Re: 1620 SW 27th St
Lot 44, Whispering Woods
Lee's Summit, MO 64082
Permit: PRRES20215563

Apex Engineers Inc. observed the house under construction at the above-referenced address. Our firm has been retained to address comments from the city rough-in inspection. For the purposes of this report, the house will be referred to as facing south.

Figure 1.0 – Kicker Detail

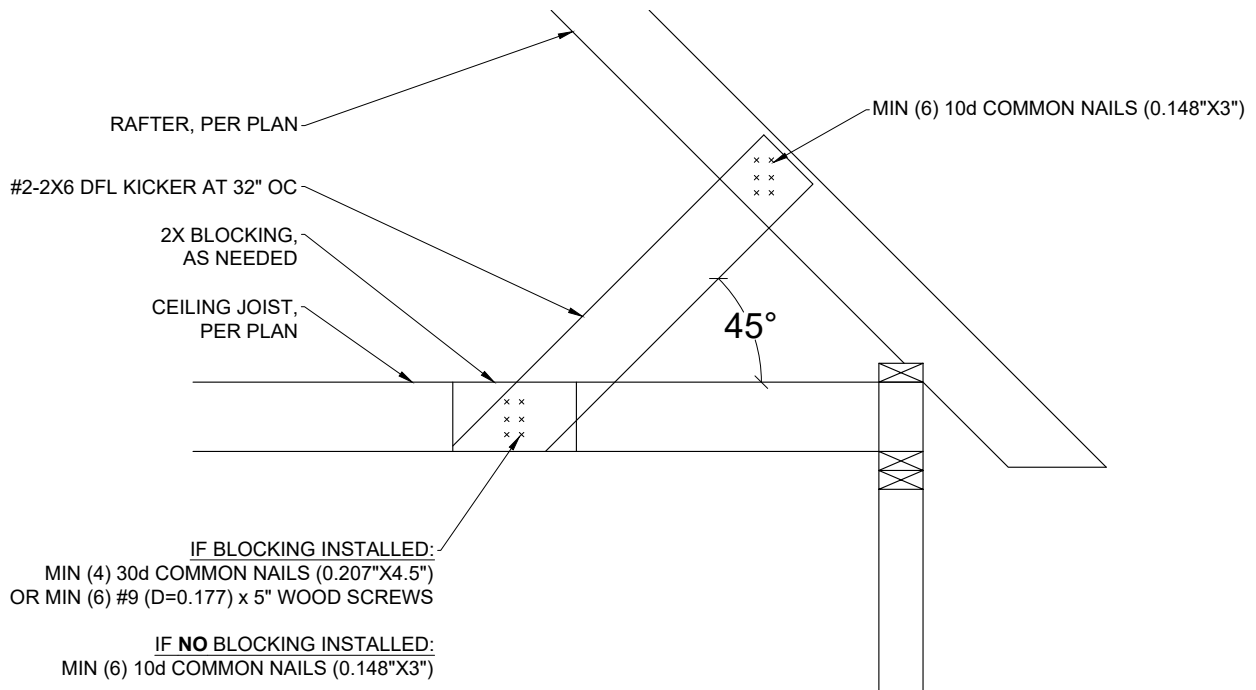
1. *Address ceiling joists to rafter connection throughout*

- Rafters shall be connected to ceiling joists with #2-2x6 kickers at 36" on center, installed at minimum 45-degree angle from horizontal and fastened per Figure 1.0.

Figure 2.0 – Master Bathroom Entry Notches

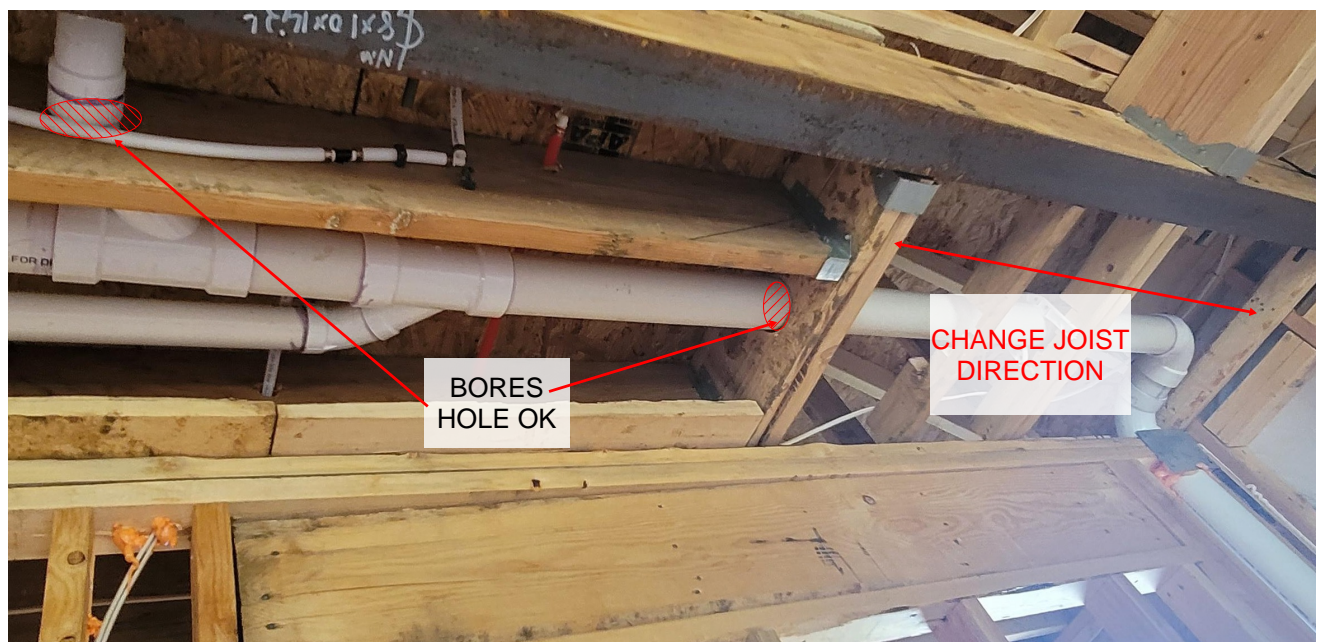
4. *Over-notched ceiling joists above master bath entry*
 - Two 3" diameter bore holes were observed in floor joists at the master bath entry and were determined to be within allowable IRC limitations.
 - Two large square notches were observed in ceiling joists at the master bath entry. Our firm recommends replacing the ceiling joists with DFL #2-2x6 at 16" on center and rotate the joist direction 90 degrees. Reference Figure 2.0.

Figure 3.0 – Cut Joist Repair

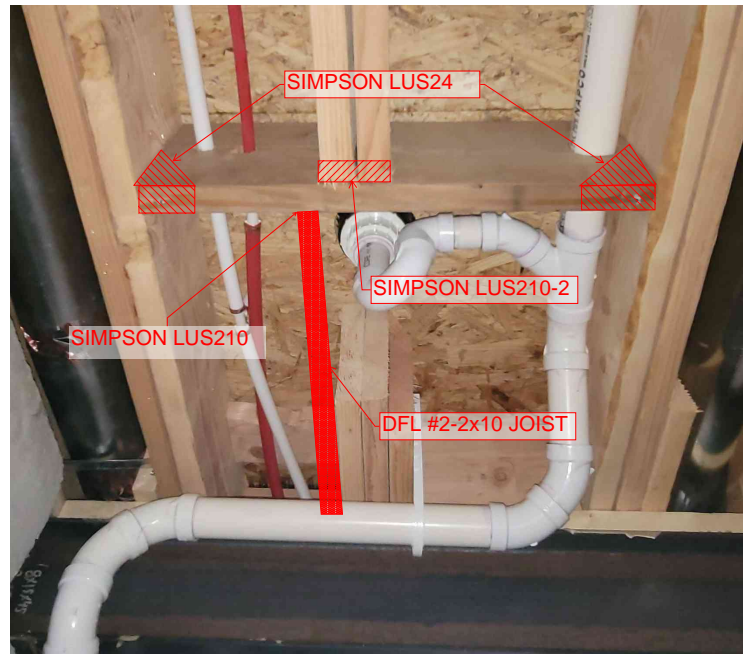
7. *Address joist cut for DWV W wall basement*
 - The cut joist shall be hangered into a single ply DFL #2-2x10 header beam with Simpson LUS210-2 face mount hanger. An additional 2x10 joist shall be installed on the backside of header beam and fastened with Simpson LUS210 face mount hanger at one end and bear on steel beam at the other end. The header beam shall be fastened to adjacent joist bays with Simpson LUS24 hangers each side. Reference Figure 3.0.
